# Memo

LES CLEMENTS  
District Supervisor

WILLIAM G. ROSS - A. G. RODGERS Com HLP 5-18-26  
ATOKA PENN GAS

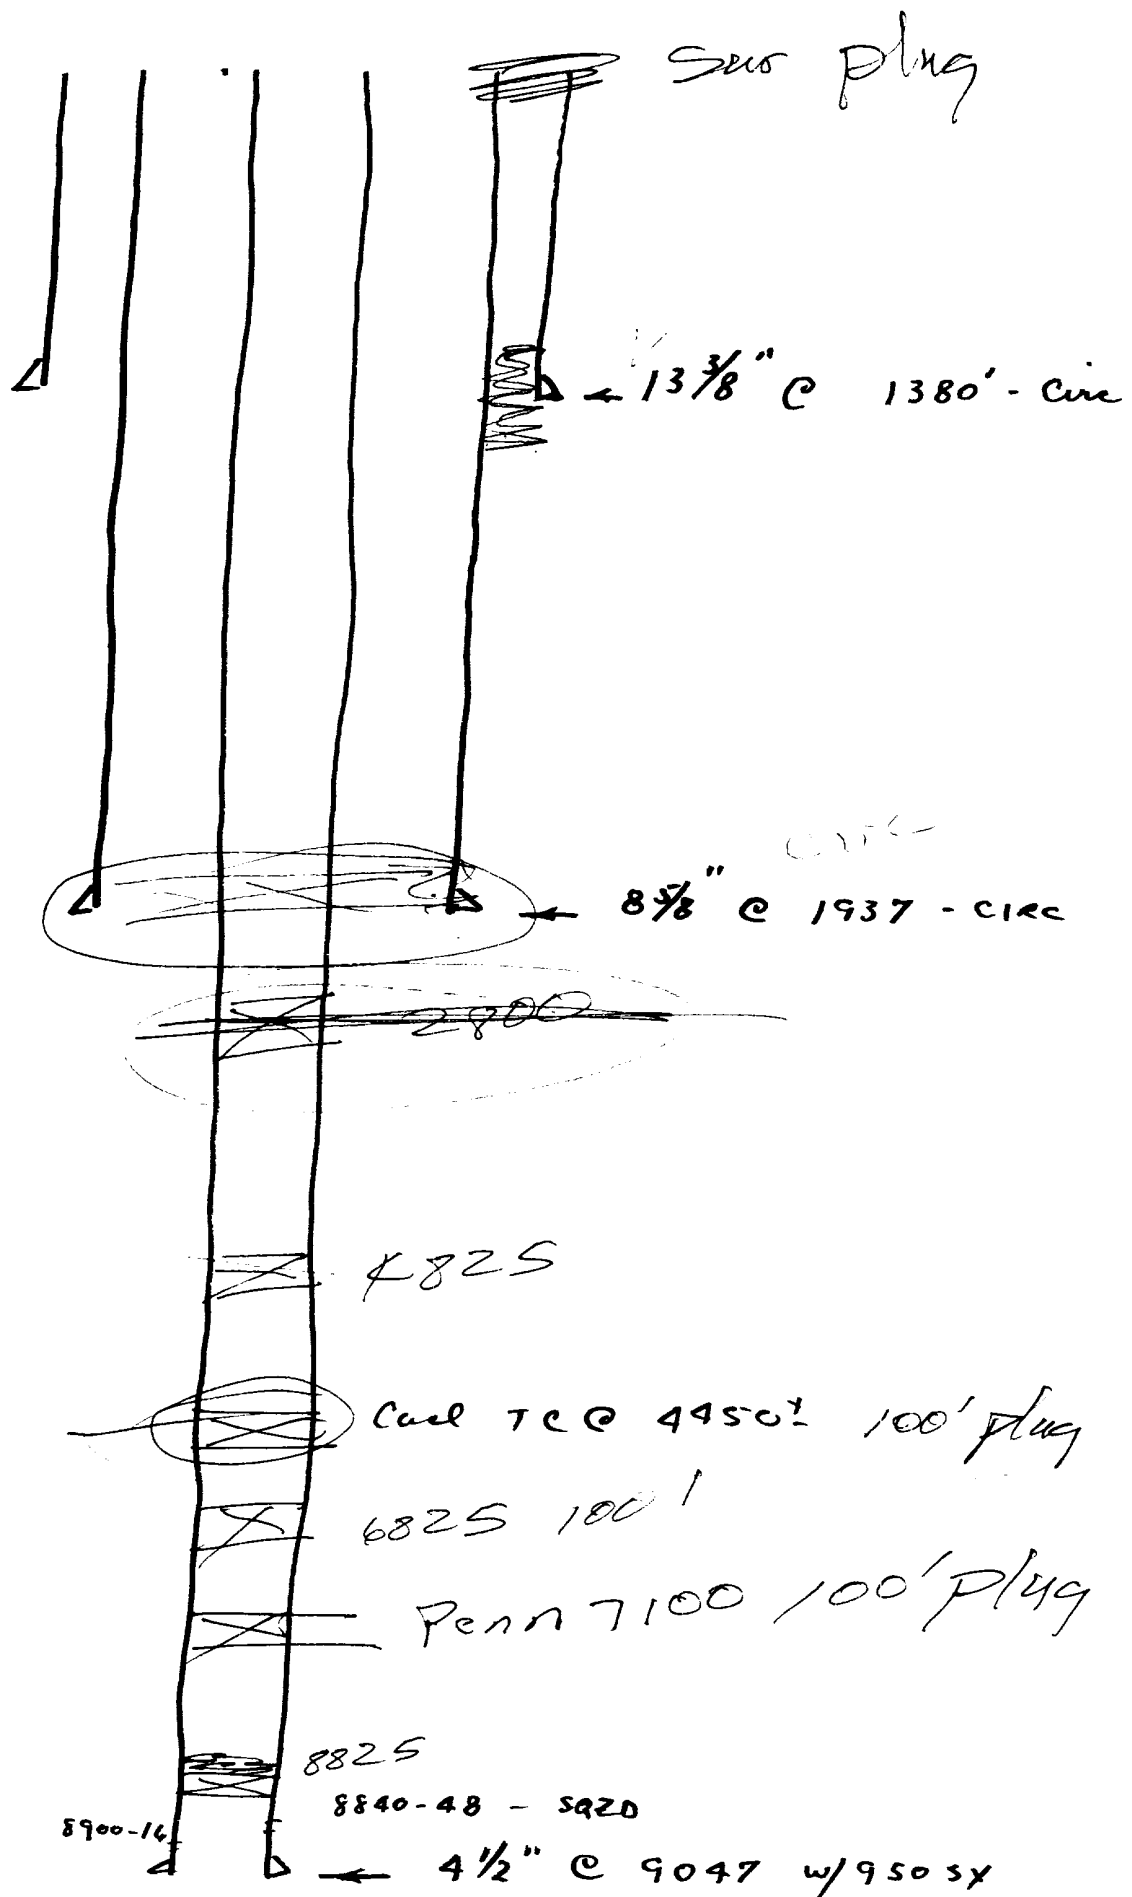
- CIBP
- ① 8825 w/35' cap
  - ② 7100 100' plug
  - ③ Stub plug + Tag
  - ④ 1987 100' plug
  - ⑤ 100' Plug @ 1930

1. Set CIBP + 35' Cmt @ 8825'  
(NOTE IF CIBP USED DO NOT HAVE TO WOC  
IF CIBP IS NOT USED  
SET 100' CMT PLUG @ TOP OF  
PERF'S WOC AND TAG
2. DISPLACE HOLE TO MUD
3. SET 100' PLUG @ 6825'
4. SET 100' PLUG @ 4825'  
(TOP OF CMT @ 4458')
5. SET 100' PLUG @ 2800'
6. SET 100' PLUG @ 1937'
7. SET 100' PLUG @ 1380'
8. SET 105X CAP W/ MARKER

NOTIFY OCD 24 hrs PRIOR  
TO SETTING BOTTOM PLUG

NEED TO PUT THIS PROCEDURE ON  
ENCLOSED C-103'S - NOTICE ~~ON~~ OF  
INTENTION.

AND WHEN FINISHED ON SUBSEQUENT  
REPORT
